APPROVED MINUTES

February 21, 2013 Standards Committee Meeting **(Changes to the Final Draft on pages 5, 152 and 194 shown highlighted yellow)**

RE: Minutes from the February 21, 2013 Standards Committee Meeting

805-SGCF-04 SIGNAL HANDHOLE (WITH MARKUPS)

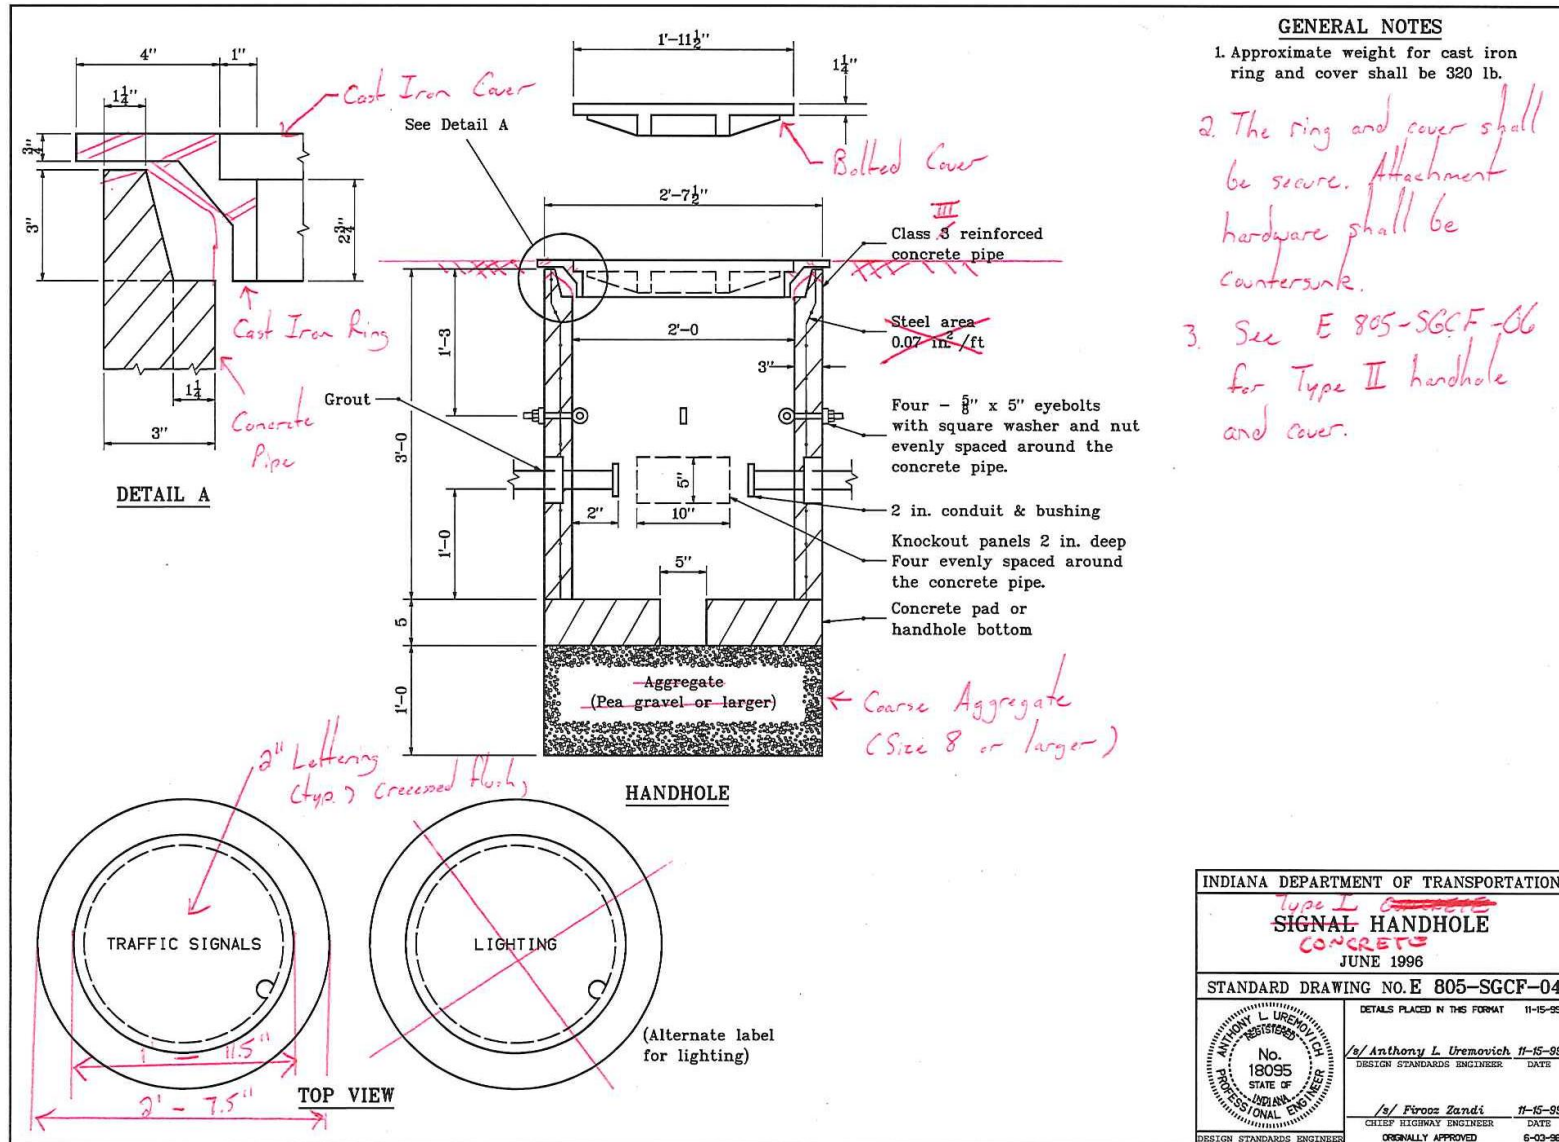
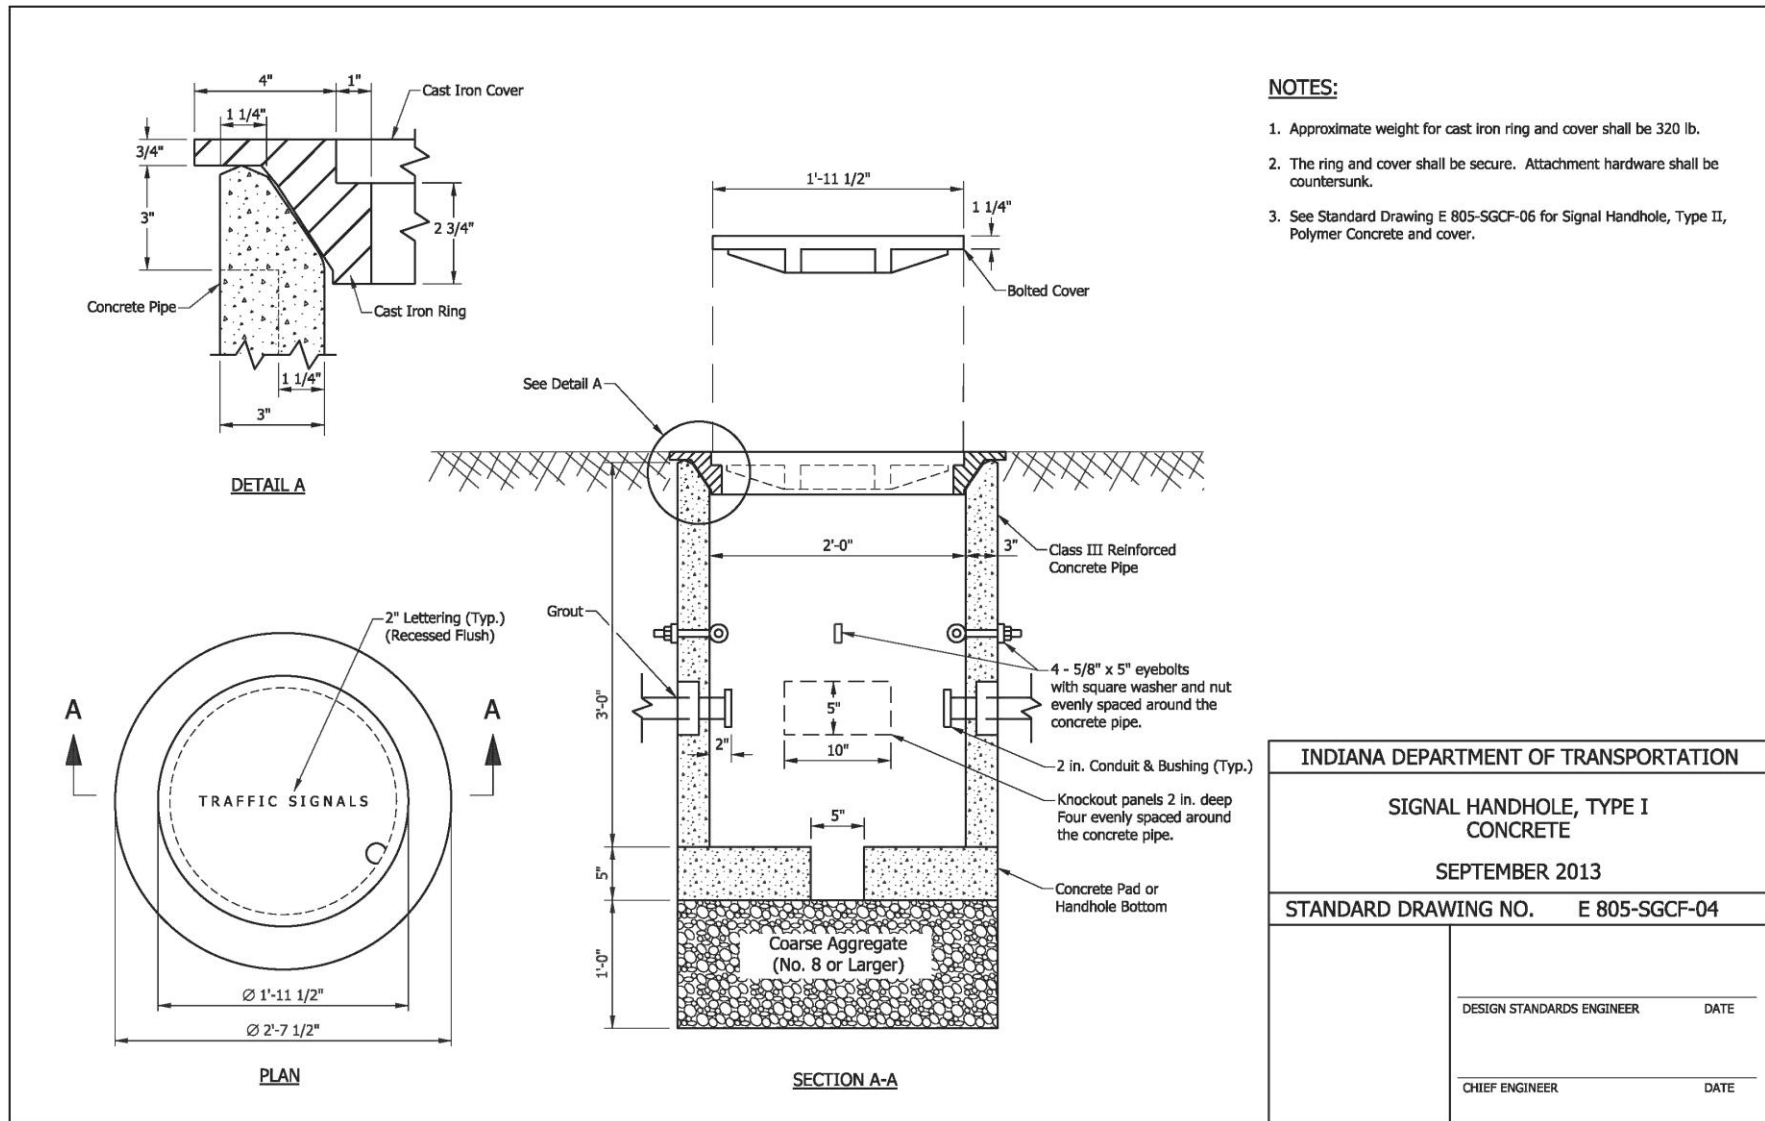
DISCUSSION: Mr. Boruff introduced and presented this item stating that the revisions and comments and suggestions from previous meetings have been incorporated into this proposed item. It was agreed to revise the notes on drawing 805-SGCF-05, and the drawings that are affected by this revision. Revisions were also made to 805.03 as shown, as well as other minor editorial revisions throughout the proposed 805 and 922 sections.

Revise Standard Drawing 805-SGCF-04 for concrete handholes and create a version for polymer concrete handholes. Delete Standard Drawing 805-SGLT-01.

805-SGLT-01 LOOP TAGGING SYSTEM (PROPOSED TO DELETE)

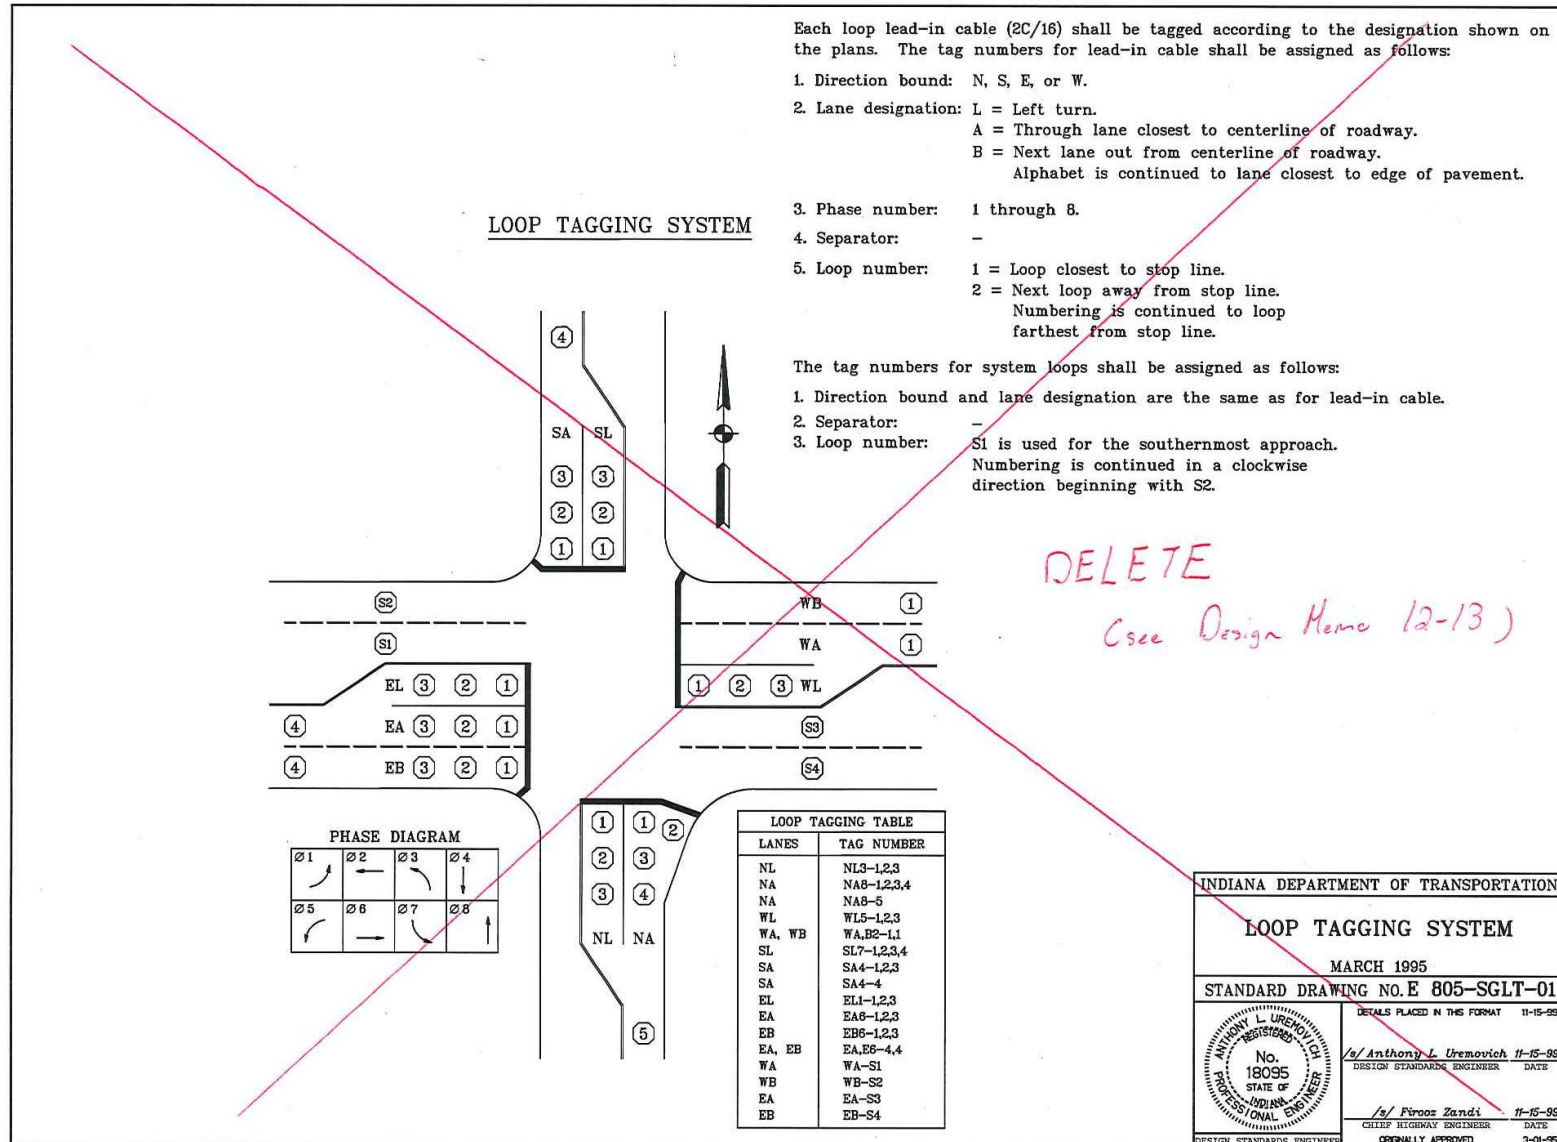
Standard Drawing 805-SGLT-01 detailing the loop tagging table is not accurate and is redundant since the designer provides this information (see Design Memo 12-13).

731-MSEW-01 MSE WALL CAST-IN-PLACE CONCRETE COPING (REVISED DRAFT)

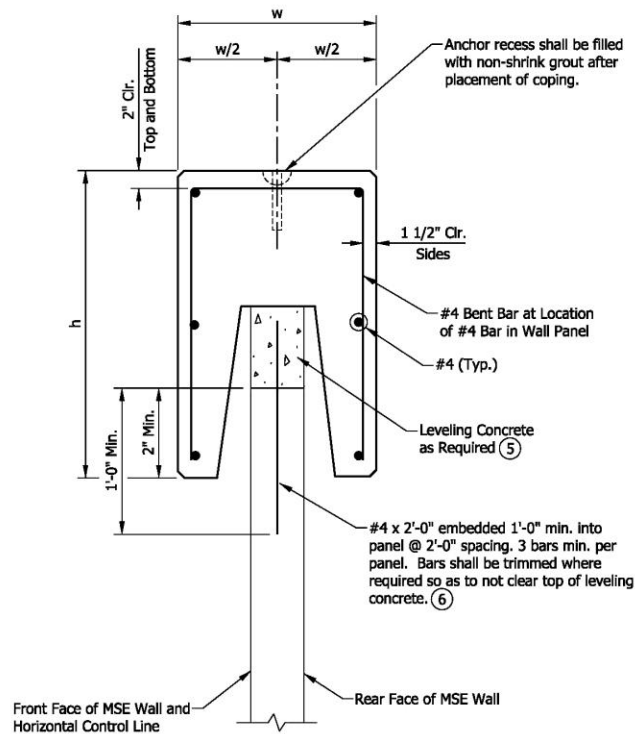
PROPOSED SOLUTION: Add notes clarifying use of leveling concrete to Standard Drawing 731-MSEW-01. No changes are proposed for the remaining drawings in the 731-MSEW series. No changes are proposed to the related Standard Specification 731 or active Recurring Special Provision 731-R-597. Leveling concrete will continue to be considered an "incidental" wall material and should be included in the cost of Face Panels, Concrete per 731.13.

BACKUP 01. IDM, FIGURES 404-2B and 404-2C

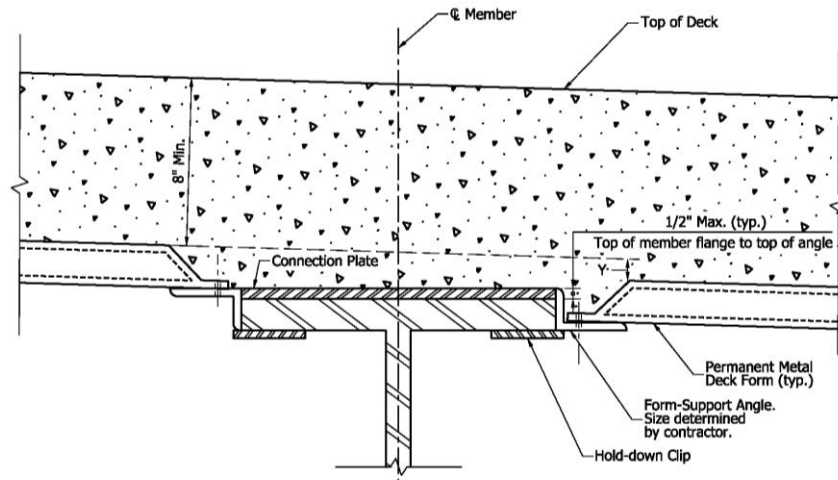
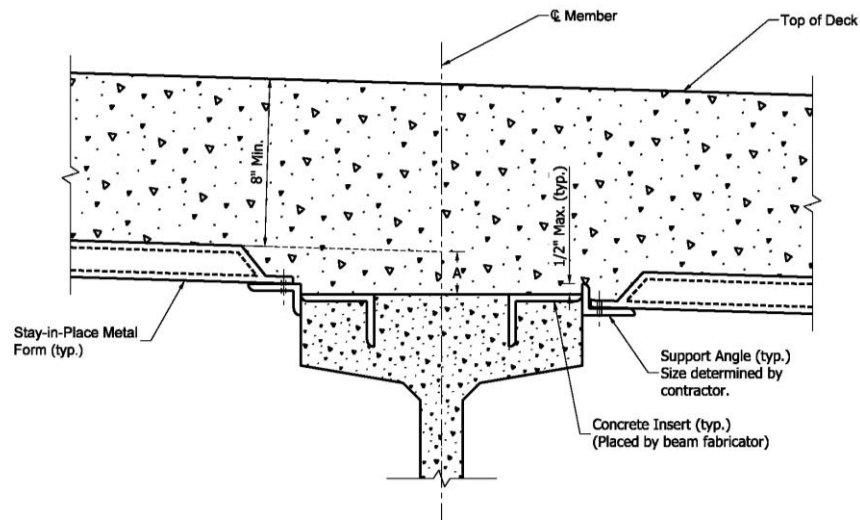
2. The improper installation of stay-in-place (SIP) metal deck forms can cause cracking. Limiting the projection of the form support above the top flange to 1/2 inch is considered adequate to reduce the likelihood cracks. Figures 404-2B and -2C illustrate the connection of SIP forms and instructs the designer to detail the connection on the plans. Because the engineer of record is not responsible for the design for the SIP forms, the plans are not the appropriate place for this information.

PROPOSED SOLUTION: Incorporate the proposed changes into the 702 section and to amend section 702.13 (e) 2. to limit the projection of the form support to a maximum of 1/2 in. above the top flange. Revise the Design Manual to refer to Figures 404-2B and -2C as typical connections and delete the requirement to detail the connection on the plans.
